# CITY OF CHARLES TOWN
## HISTORIC LANDMARKS COMMISSION
## AGENDA • FEBRUARY 10, 2025

## COA2024-25: 524/526 E. Washington Street - Window Replacement

Certificate of Appropriateness
**COA 2024-25**

**Certificate of Appropriateness**
**COA-2025-01**

## PROPOSED DESIGN

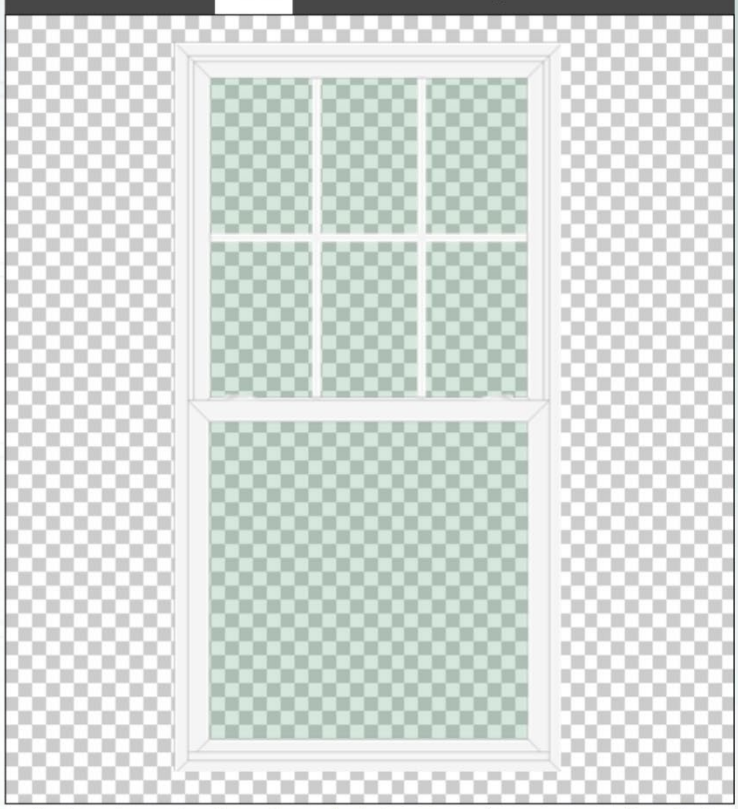
The applicant proposes to take out the existing windows and replace them with vinyl windows with a wood frame and PVC brick molding. Applicant proposes to construct an L-shaped aluminum frame to conceal any unfinished or exposed wood between the new windows and the original brick.

The existing design of the windows is a 6/1 double hung configuration. A wooden frame will be put int place for each window.

## RECOMMENDATION

**Approval subject to conditions:**

-The replacement windows shall be of 6/1 double hung design.

**DESIGN**

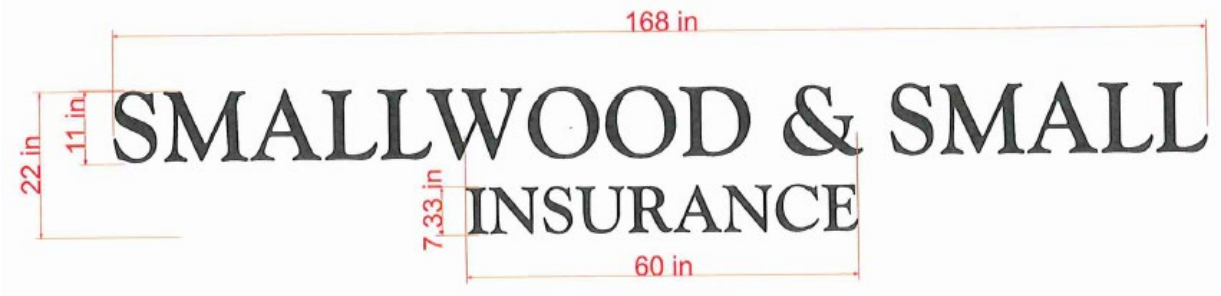
**MATERIAL:** Acrylic.

To be stud-mounted in the brick. Per the applicant:

*"The friction fit means that we will drill the holes large enough to press the studs into. This friction would keep them pretty much in place. But we also add silicone on the studs to firmly hold the studs in the holes. As for the brick, we can have these made so that the studs line up with the mortar lines, so the actual brick isn't drilled."*

**SIZE:**
Height: 22 inches/ 1.8 ft.
Width: 168 inches/ 14 ft.
Depth: .5 inch
